January 11, 2022
7:00 PM
Planning Board Agenda

Public hearing on applications for Subdivision Approval (lot merger) and Site Plan Approval, three-story mixed-use residential and commercial development, 364 Main Street, submitted by O'Donnell Construction Corp.

Re: 364 Main Street, Beacon, New York
Site Plan Application – Responses to Comments

Sheet 5 of 12 - Building Elevations

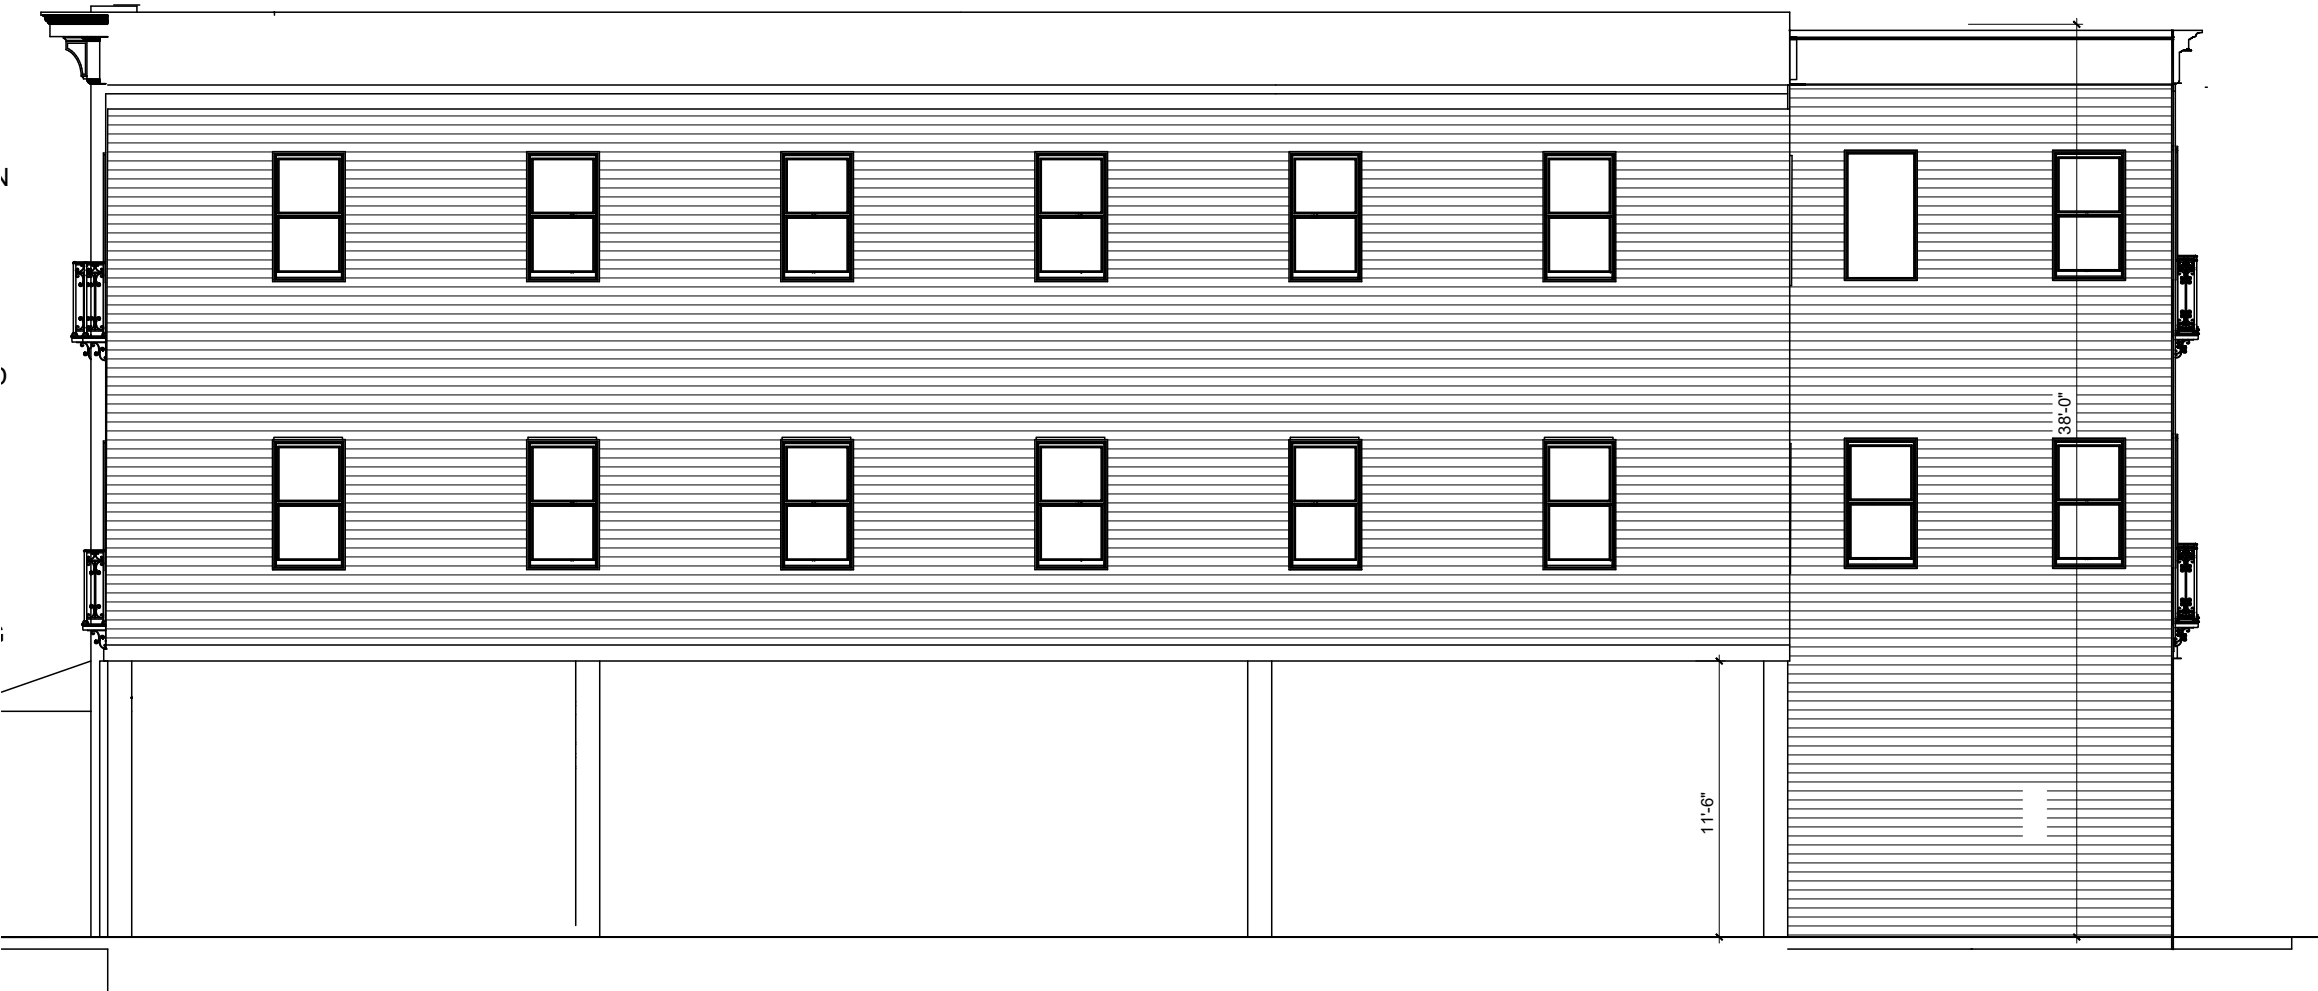
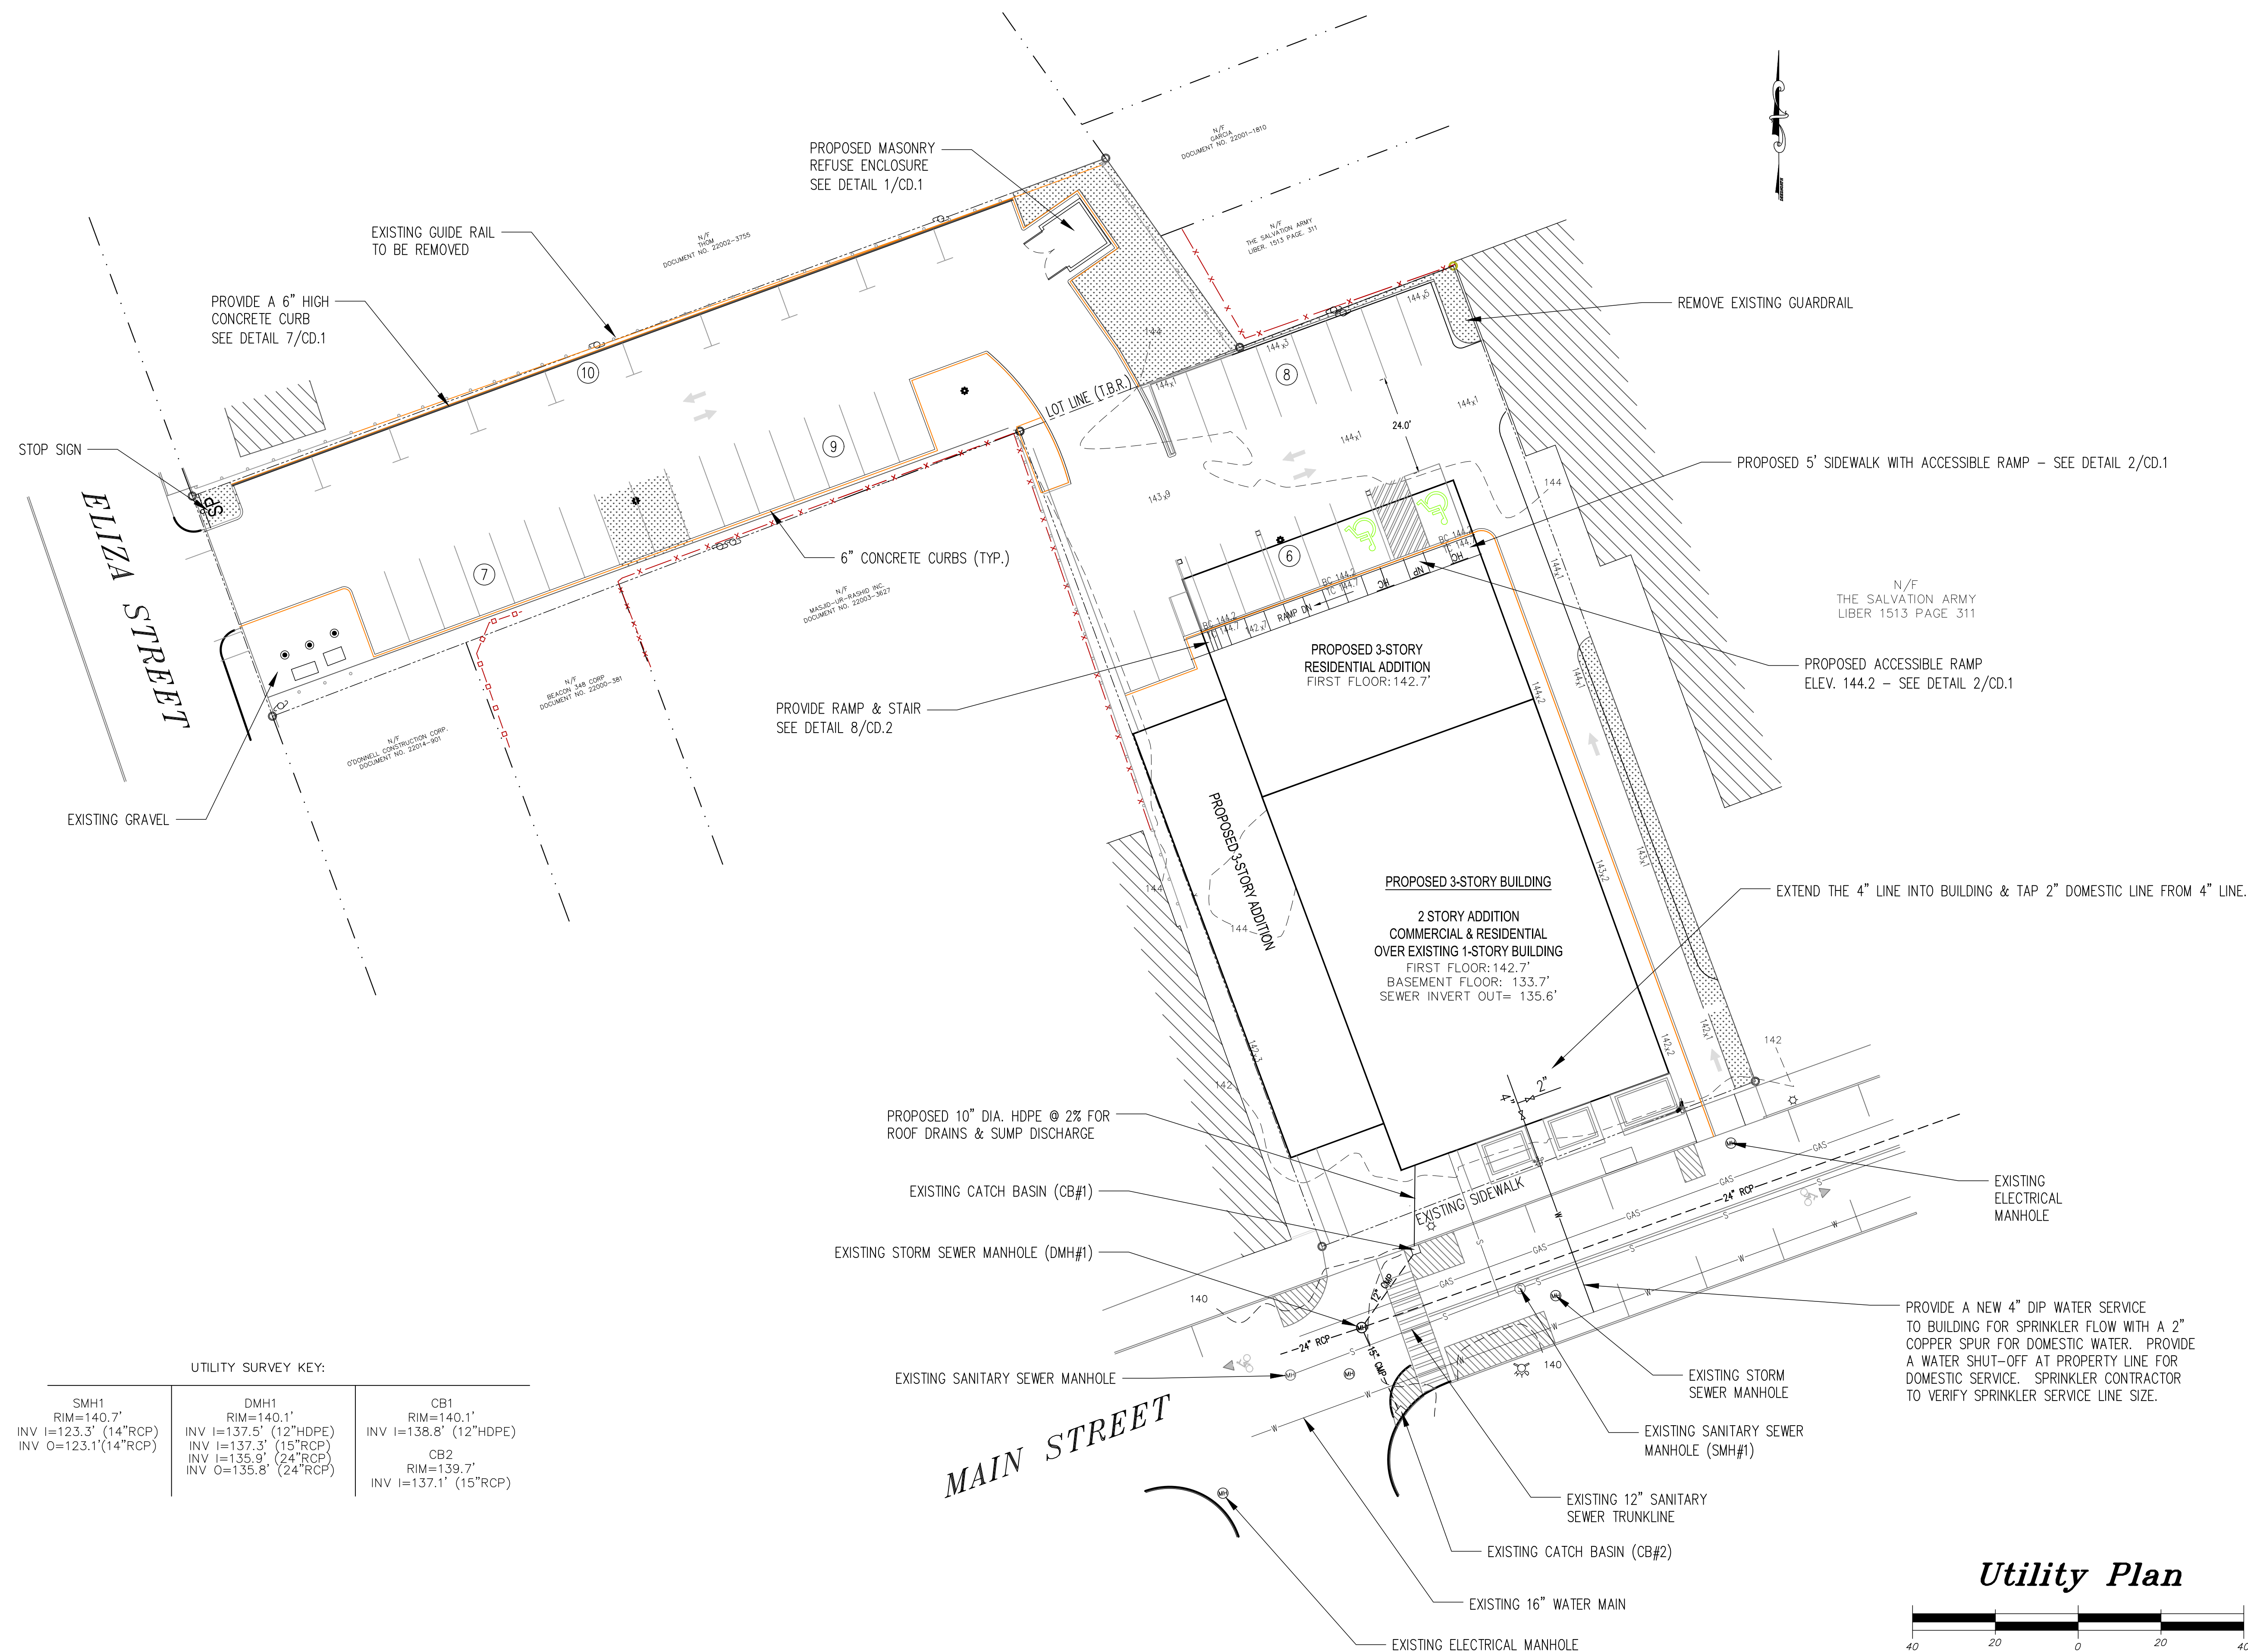
1. The main street views reflect the building setback. The views are for building design only and do not reflect the landscape design shown on Sheet 1 Site Plan.

Erosion & Sediment Control Plan

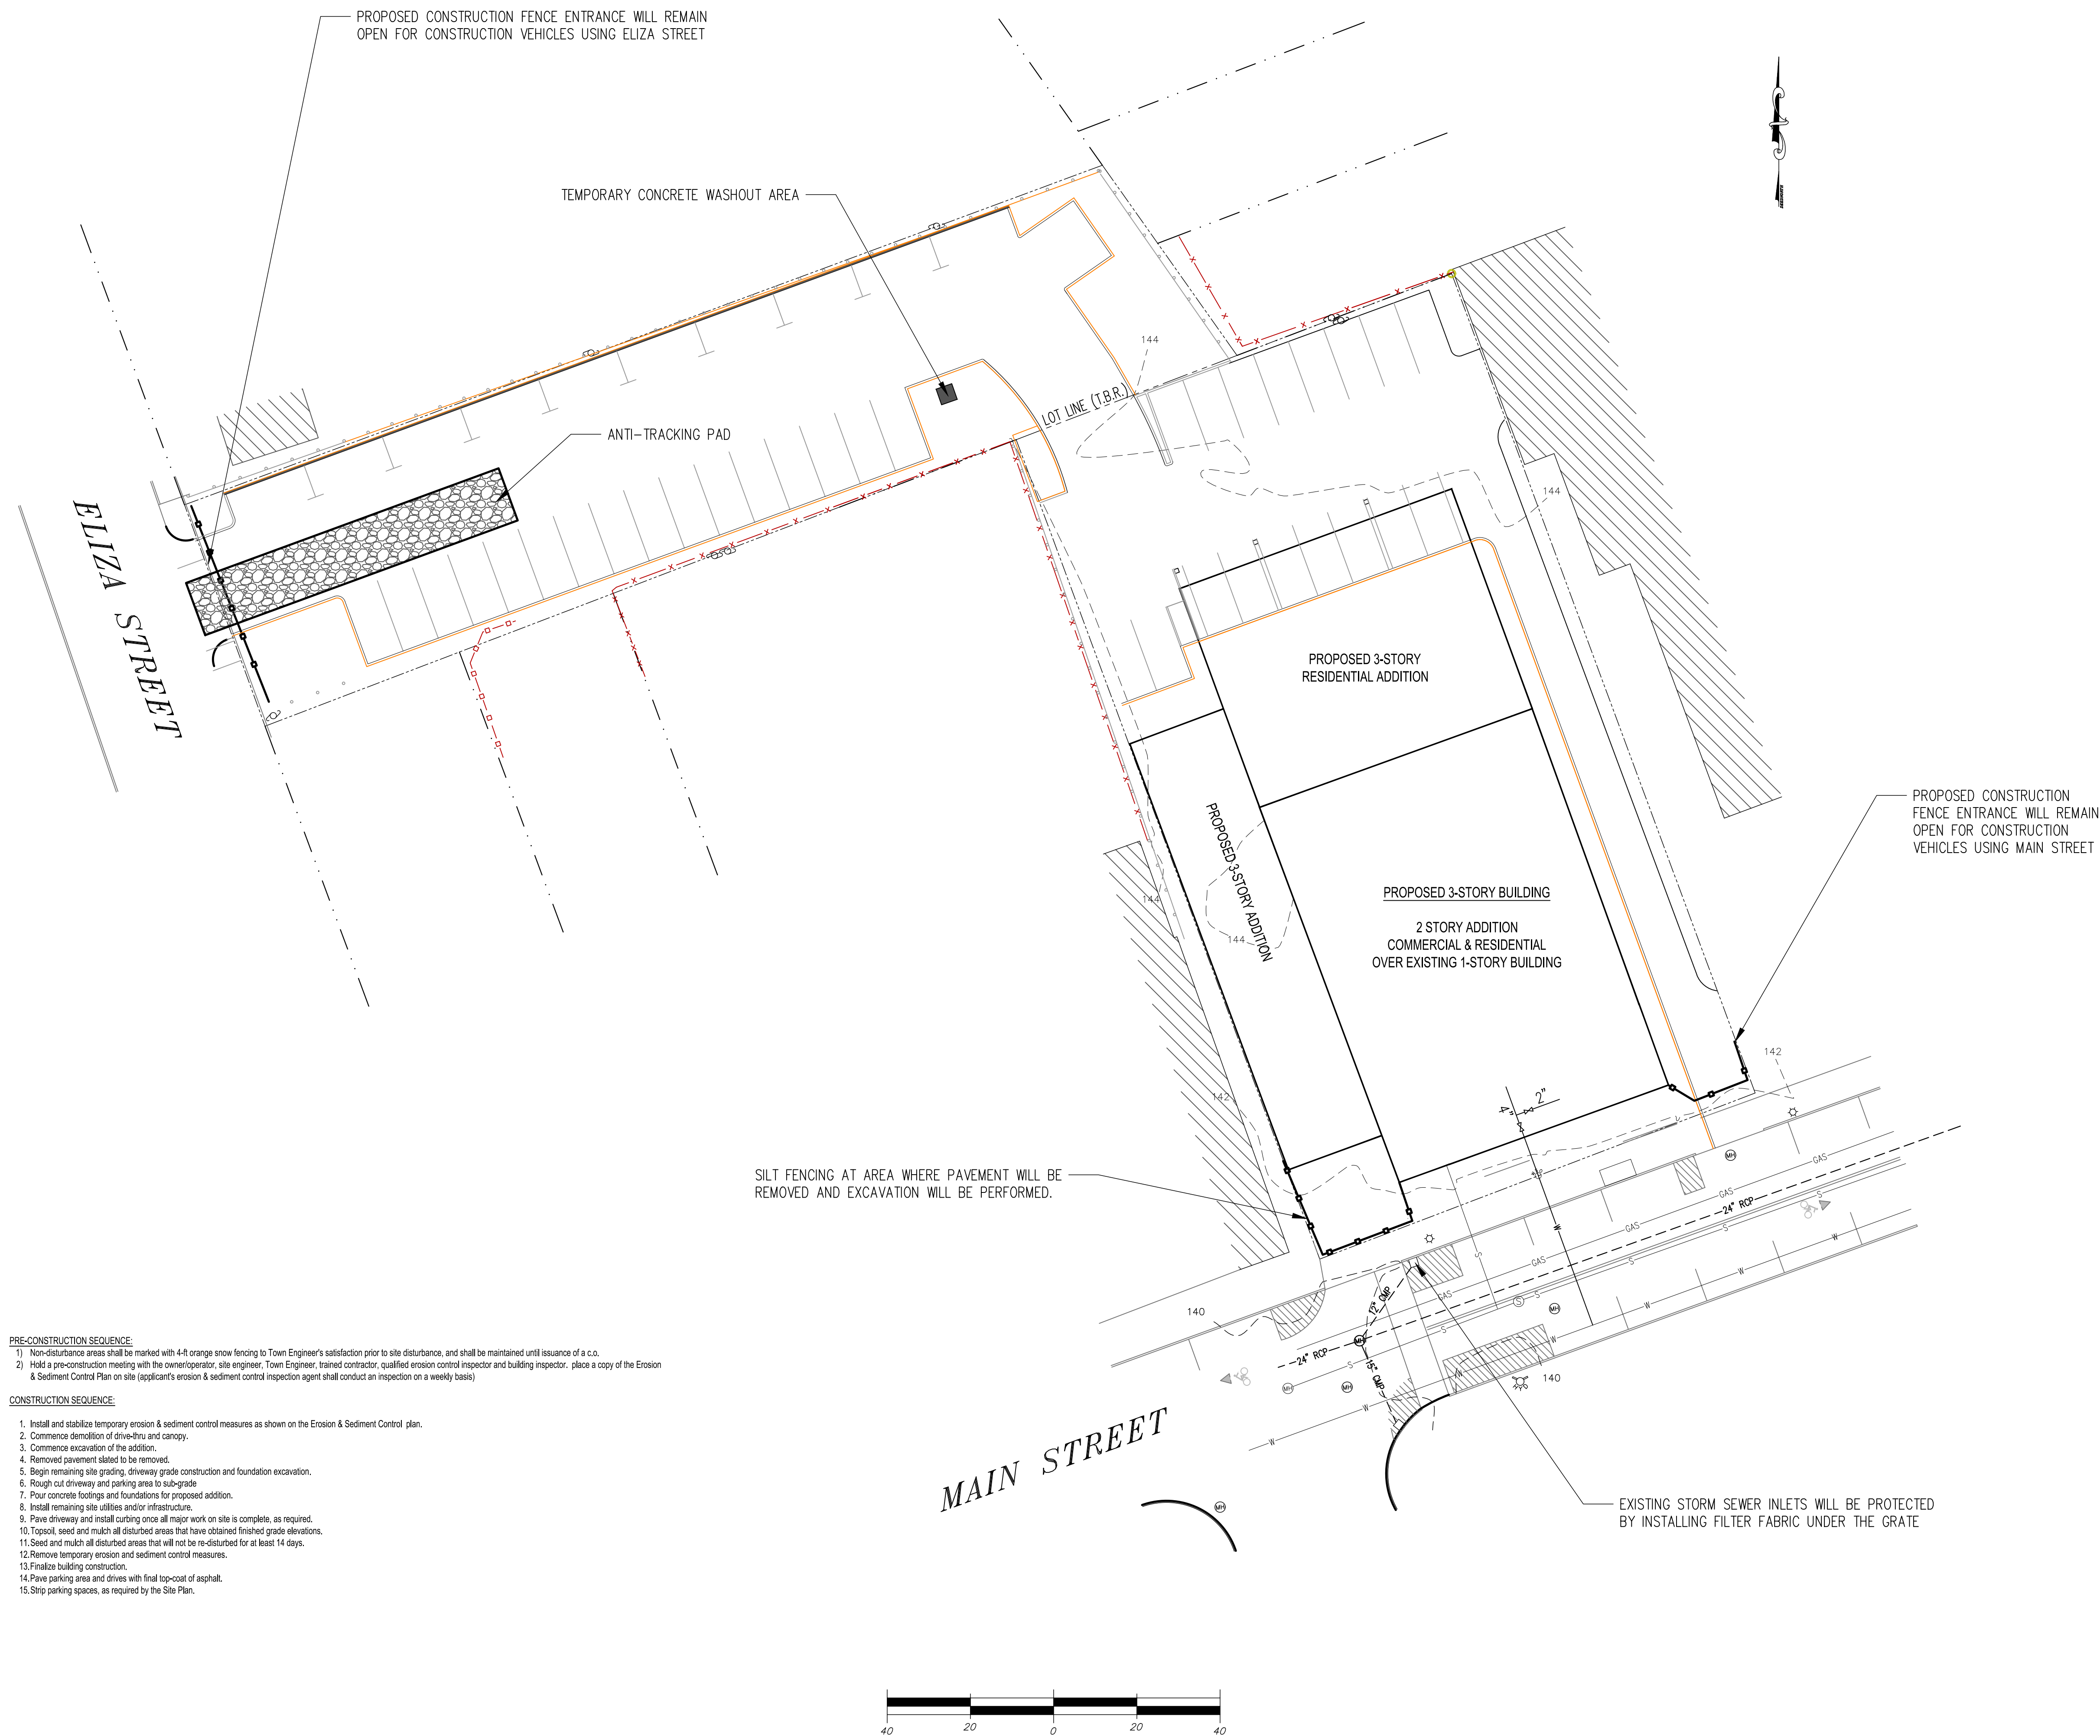
1. The "Filter Fabric Drop Inlet Protection" detail shall be revised to reflect the note provided on Sheet 13 of 14 (ESC.1), as the protection cannot be provided as currently shown in the detail.
2. A detail shall be provided for the "Temporary Concrete Washout" called out on Sheet 13 of 14 (ESC.1).
